Inspection Report
Minerals Regulatory Program
Report Date November 23, 2005

Mine Name: DKG Quarry
Operator Name: Diamond K Gypsum

Permit number: M/015/041
Inspection Date: November 22, 2005
Time: 11:00 AM to 12:20 PM

Photo 1. The operator will try to knock down the pile of waste material in the center-right of this photo and cover it with soil.

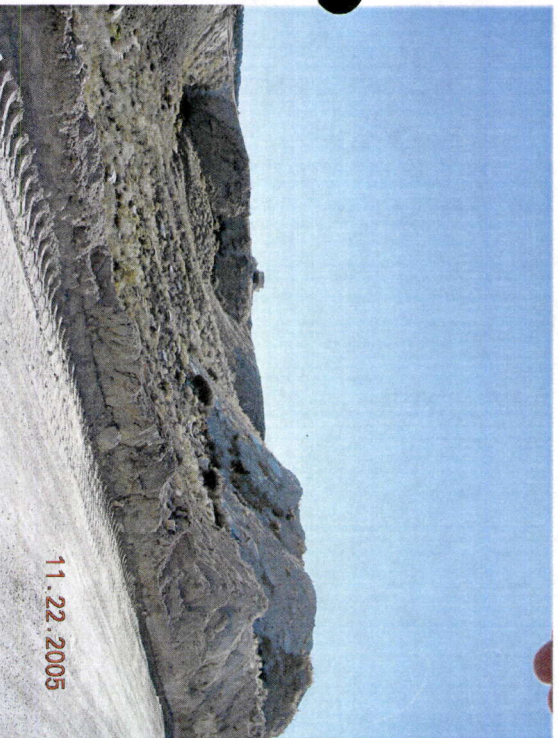
Photos 1 and 2 show a pile of waste material (mostly gypsum, it appears) that the operator will grade. This will mean disturbance of a slightly larger area.

Photo 2. Another view of the waste material shown in Photo 1.

Photo 4. Gravel that the operator is going to try to spread over some of the reclaimed surface.

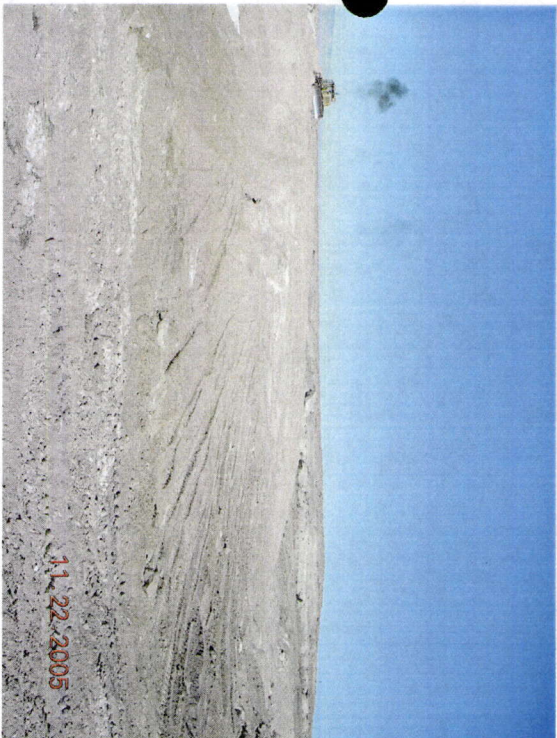
The soils in the area being reclaimed are fine textured and have very little rock, unlike the areas reclaimed in 2004. This concerns me because rocks tend to increase water infiltration and decrease runoff. There was an area with very gravelly soil on the southwest side of the area being reclaimed, and I suggested to Mr. Henry that, as far as possible, this could be spread over the top of the area being reclaimed.
